WARRANTY BULLETIN

WB18-09

SUBJECT: BATTERY GROUND CABLE CRIMPING

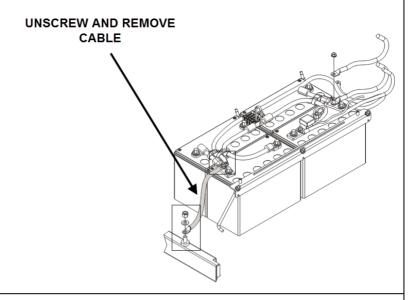
3. Disconnect the cable at the battery terminal and chassis ground stud. Remove the cable from the vehicle.

Slide out of the housing – cut cable tie if present.

NOTE: Clean chassis ground stud, remove rubber coating.

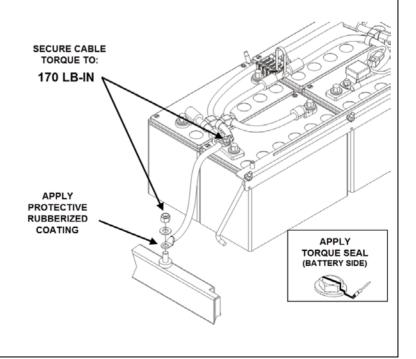
5. Secure the cable at the terminal end and chassis ground stud. Torque nuts to **170 lb-in.**

Apply a strip of torque seal to the fasteners on the battery side of the cable.

Re-apply rubber coating on the ground stud /chassis connection.

Secure the cable to the plastic housing using a large cable tie.
